THE UNIVERSITY OF TEXAS
 COLLEGE OF ENGINEERING
 AUSTIN, TEXAS 78712

July 30, 1982

Review of Phase I
Instrumentation Changes
7-29-82

UT TRIGA Reactor Control
and Instrumentation Changes

Installed Version
Functional block diagram

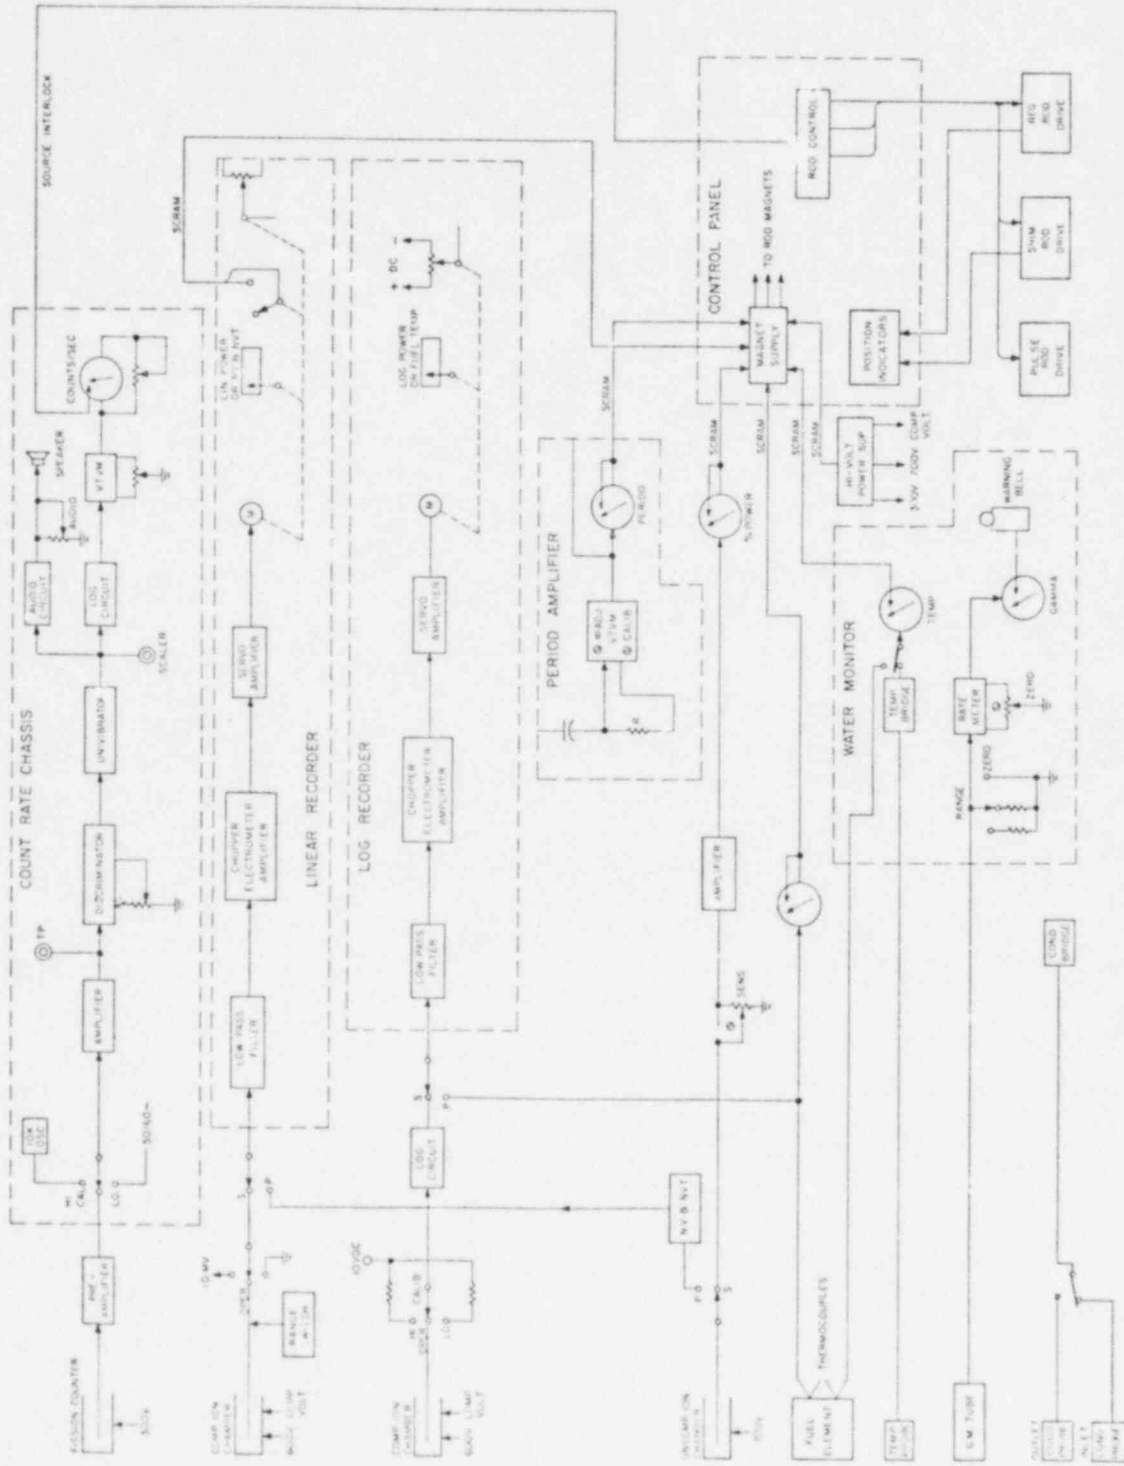
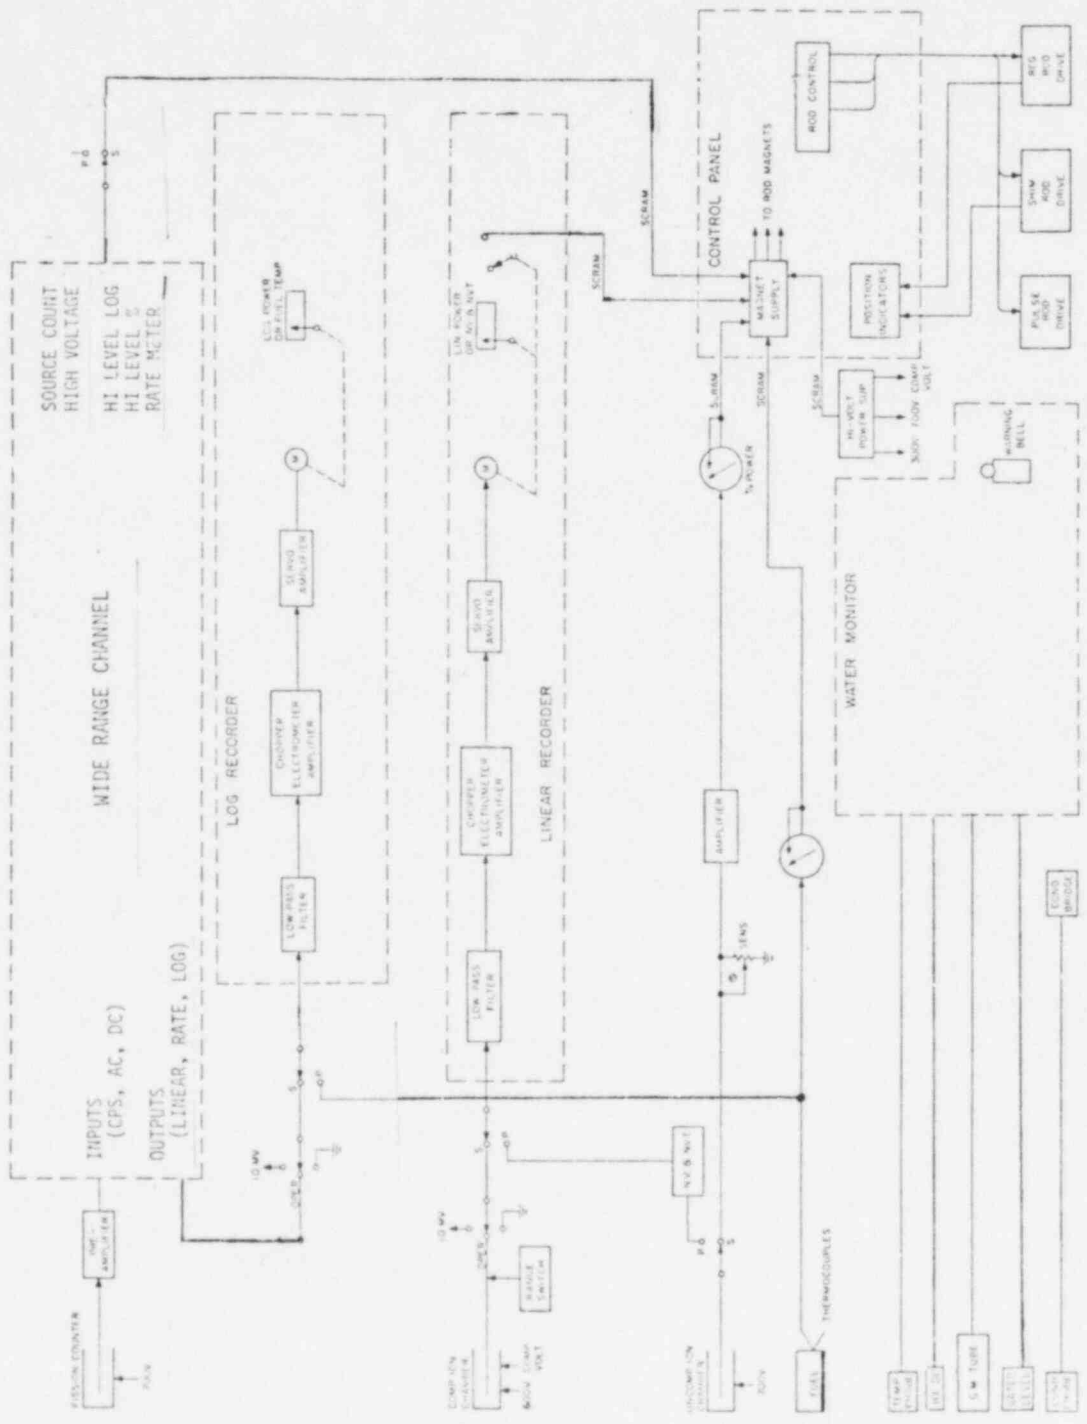
- a. A single counter/chamber that operates on ac and dc current or pulse mode replaces the function of two separate detectors. The fission counter provided neutron source counts and rod withdrawal interlock. The ionization chamber measured log power and period scram. Replacement of the two detectors that operated in non-overlapping regions of neutron flux level by a single detector capable of both types of measurements does not increase the probability of occurrence or consequences of an accident or malfunction of equipment important to safety.

- f. Removal of log channel with its functions is replaced by functions of the wide range channel that have equivalent or decreased probability of occurrence of consequences of equipment malfunction. Neither a different type of accident nor the margin of safety required by technical specifications have been altered by the channel replacement.

- g. Removal of the startup channel and its functions is replaced by functions of the wide range channel that have equivalent or decreased probability of occurrence or consequences of equipment malfunction. Neither a different type of accident nor the margin of safety required by technical specifications have been altered by the channel replacement.

Wide Range Channel Installation
Functional block diagram

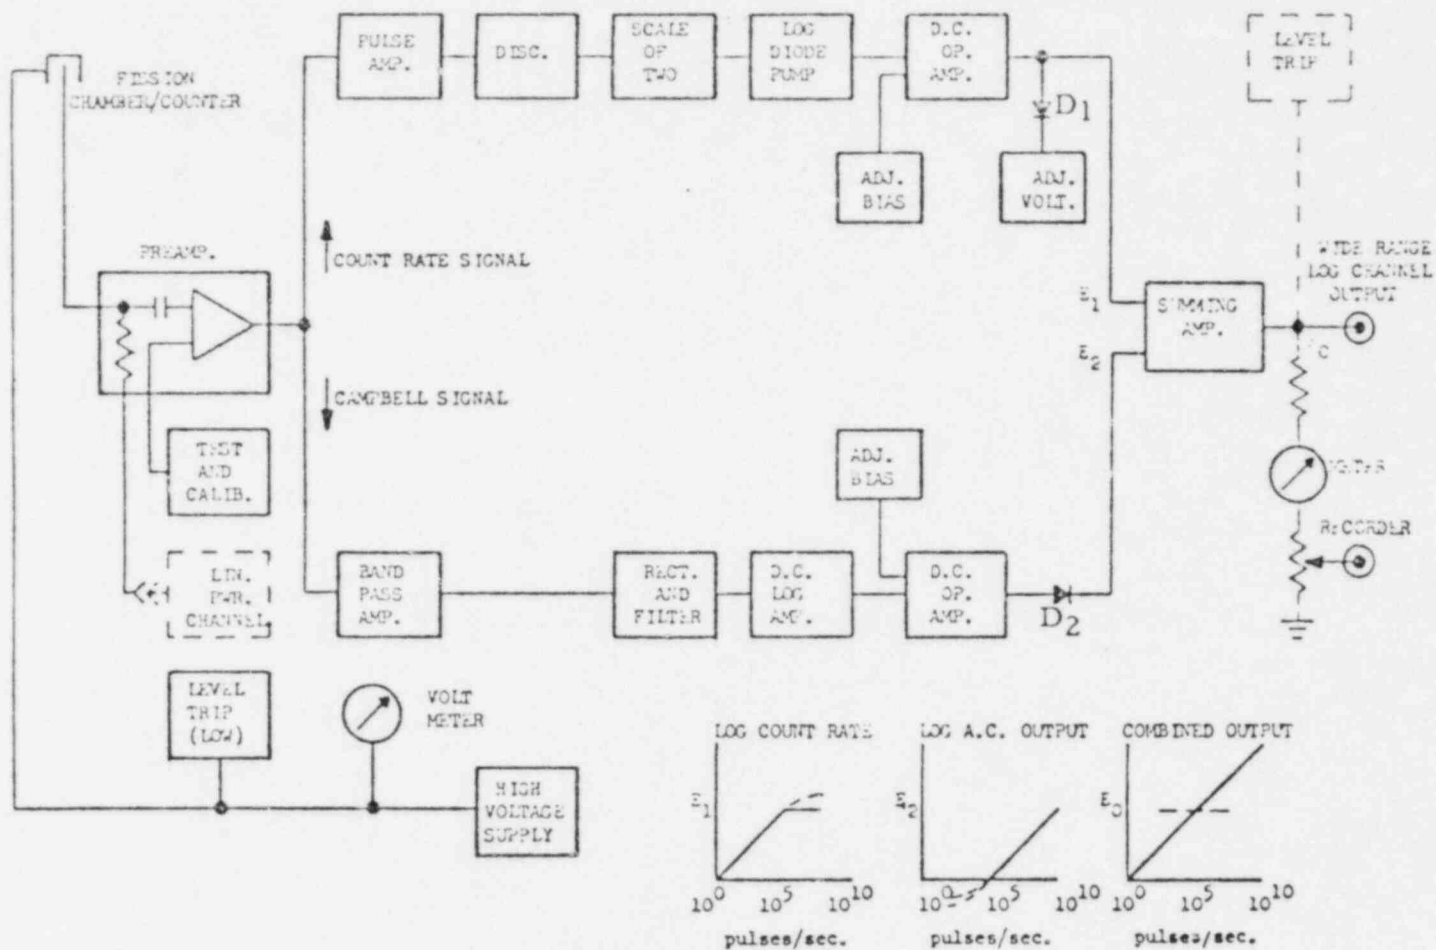
A wide range channel instrumentation unit manufactured by General Atomic for nuclear reactor instrumentation is to replace the functions of the original GA log compensated ionization chamber and channel, and the source range startup fission counter and channel. The fission counter/chamber is a Reuter Stokes RSN-314A with GA PA-5 preamplifier and GA model NLL-2F Linear and Log Safety Channel which had been previously installed as instrumentation at another facility.

- B. Install wide range channel function.
 1. Fission chamber for wide range measurements is positioned at previous log channel location.
 2. General Atomic Wide Range Channel is calibrated and tested and chamber positioned for correct measurements.

3. Wide range recorder output is routed to the log recorder with appropriate change of scale and calibration signal.
 4. Chassis wiring of console is modified physically to allow more convenient placement of instrument components, but all electrical characteristics remain unchanged.

Installed Version
 -- Magnet and scram circuit

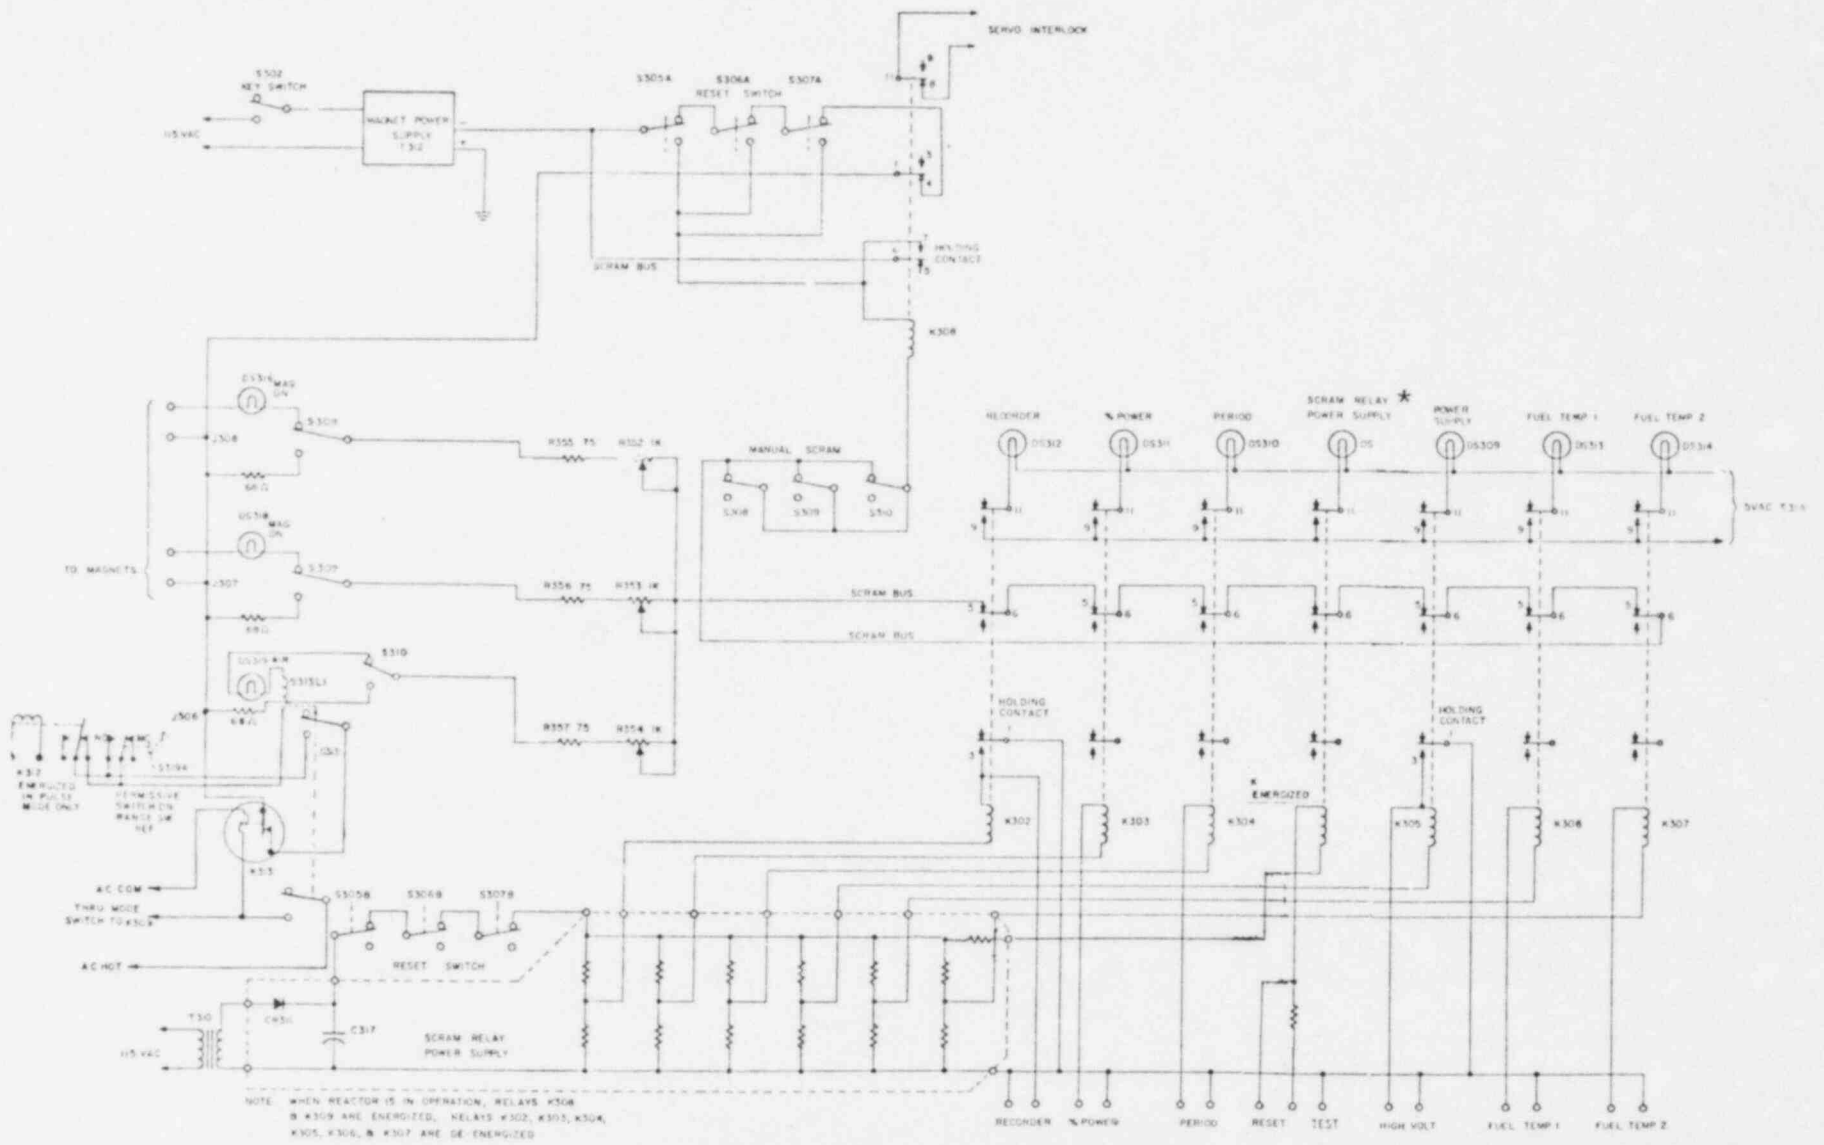
- b. The source count interlock to prevent control rod withdrawal at less than 2 counts per second neutron indication is replaced by a scram bus signal preventing rod withdrawal. Substitution of a scram bus open for the control rod power open represents a more conservative approach to effecting the source interlock since the rod drive interlock prevented rod motion on loss of source count whereas the scram signal provides for reinsertion of rods. Functional design of the source count circuit is similar to the replaced circuit but consists of new circuit elements and design feature providing increased or equivalent operation reliability.

- d. Extension of the scram bus to include the additional scrams of percent power, period, high voltage, and source level from the wide range detector increases the console safety scrams providing three power level scrams, one more than the technical specification requirement of two. No increase in probability of occurrence or consequences of a malfunction of the additional scram functions are expected.

Scram Relay Power Failure Modification*
 --Magnet and scram circuit

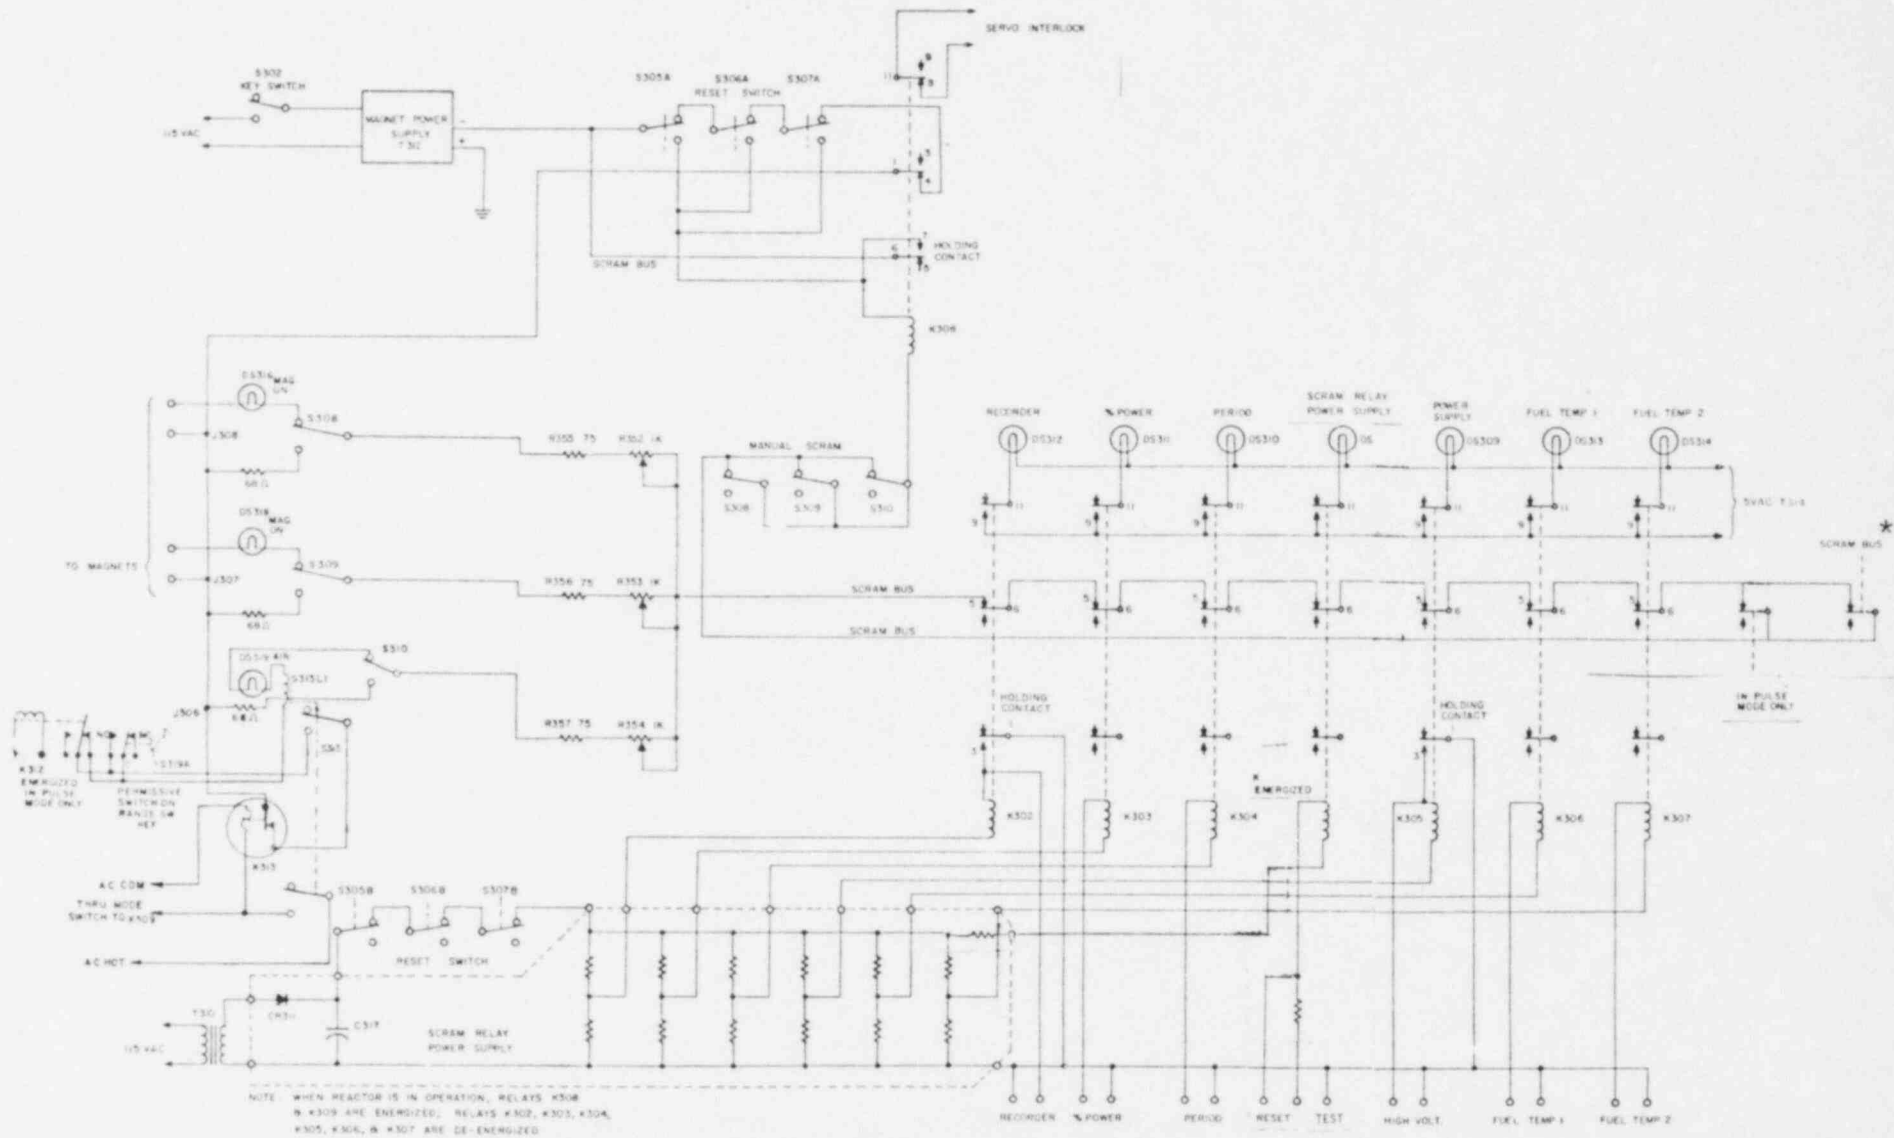
- e. Installation of pulse mode switch bypass of all wide range channel functions maintains the current console operation configuration during pulse mode operation. Any failure of the bypass maintains the wide range channel scrams. No increase in probability or consequences of occurrence are created by the pulse mode bypass.

1. Rod control scram bus is extended to include wider range channel scrams on high voltage, low source level, period, and percent linear power.
 2. Bypass of extended scram bus is installed in pulse mode switch to avoid unrequired scrams during operation.

- A. Scram relay coil function is moved.
 1. Function of decommissioned log period scram is changed to scram relay power scram.
 2. Scram relay power indication, test and reset now available for alternate function.
